Access Compliance Report

Public Rights-of-Way

(Pedestrian Signals)

Intersection ID: N/A	Main Street:	Cross Street: N/A	Location: N/A
ADA ID: C7B147DB1D7E	Signal Type: One Push Button-Non APS	Overall Compliance: No	Severity Score: BTN 1: N/A BTN 2: N/A No BTN: N/A
Codes/Mitigation Info/Possible Solution		Field Measurements/Component Compliance

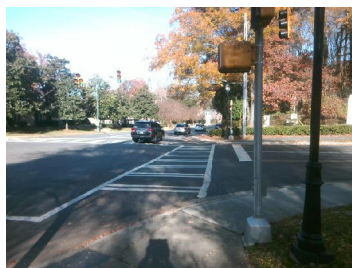
PROW/ADA: TMUTCD 4e.08, R404.1, R406.2

Compliance	Description	Data	Compliance	Description	Data
	Button Count	Button1	N/A	Distant to Additional Button (in)	N/A
	Additional Button Present?	No		Additional Button ID	N/A
N/A	Signal Buttons Required?	N/A	N/A	Additional Ped Posts Required	N/A
	How Many Ped Street Xings?	2		Located In An Island/Median?	No
N/A	B 1 Sign Present?	Yes	N/A	B 2 Sign Present?	N/A
Yes	B 1 Sign Purpose?	Yes	N/A	B 2 Sign Purpose?	N/A
Yes	B 1 Sign Lettering & Contrast?	Yes	N/A	B 2 Sign Lettering & Contrast?	N/A
Yes	B 1 Parallel To XWalk?	Yes	N/A	B 2 Parallel To XWalk?	N/A
Yes	B 1 PAR to Button?	Yes	N/A	B 2 PAR to Button?	N/A
Yes	B 1 PAR to XWalk?	Yes	N/A	B 2 PAR to XWalk?	N/A
No	B 1 Clear Floor Space?	No	N/A	B 2 Clear Floor Space?	N/A
N/A	B 1 FWD Approach?	Yes	N/A	B 2 FWD Approach?	N/A
N/A	B 1 FWD Approach Constrained?	No	N/A	B 2 FWD Approach Constrained?	N/A
No	B 1 FWD Approach Reach (in)	11.0	N/A	B 2 FWD Approach Reach (in)	N/A

N/A	B 1 FWD Approach Width (in)	N/A	N/A	B 2 FWD Approach Width (in)	N/A
N/A	B 1 FWD Approach Obstruction?	Yes	N/A	B 2 FWD Approach Obstruction?	N/A
N/A	B 1 FWD Approach Obstruction Dist (in)	9.0	N/A	B 2 FWD Approach ObstructionDist (in)	N/A
N/A	B 1 PARA Approach?	Yes	N/A	B 2 PARA Approach?	N/A
N/A	B 1 PARA Approach Constrained?	No	N/A	B 2 PARA Approach Constrained?	N/A
Yes	B 1 PARA Approach Reach (in)	8.0	N/A	B 2 PARA Approach Reach (in)	N/A
N/A	B 1 PARA Approach Width (in)	N/A	N/A	B 2 PARA Approach Width (in)	N/A
N/A	B 1 PARA Approach Obstruction?	Yes	N/A	B 2 PARA Approach Obstruction?	N/A
N/A	B 1 PARA Approach Obstruction Dist (in)	2.0	N/A	B 2 PARA Approach ObstructionDist (in)	N/A
N/A	B 1 Clear Floor Space Slope (%)	1.9	N/A	B 2 Clear Floor Space Slope (%)	N/A
N/A	B 1 Clear Floor Space XSlope (%)	4.8	N/A	B 2 Clear Floor Space XSlope (%)	N/A
N/A	B 1 PAR Slope (%)	1.1	N/A	B 2 PAR Slope (%)	N/A
Yes	B 1 Height (in)	40.0	N/A	B 2 Height (in)	N/A

Yes	B 1 Clear Xing Direction?	ClearlyMarked	N/A	B 2 Clear Xing Direction?	N/A
	B 1 Crossing Direction	To SW		B 2 Crossing Direction	N/A
Yes	B 1 DistanceTo XWalk (in)	0.0	N/A	B 2 DistanceTo XWalk (in)	N/A
No	B 1 DistanceTo Curb (in)	78.0	N/A	B 2 DistanceTo Curb (in)	N/A
Yes	B 1 Diameter (in)	2.0	N/A	B 2 Diameter (in)	N/A

Possible Solutions: Replace Signal Push Button With APS Button on New Post. Remove & Relocate Sign.
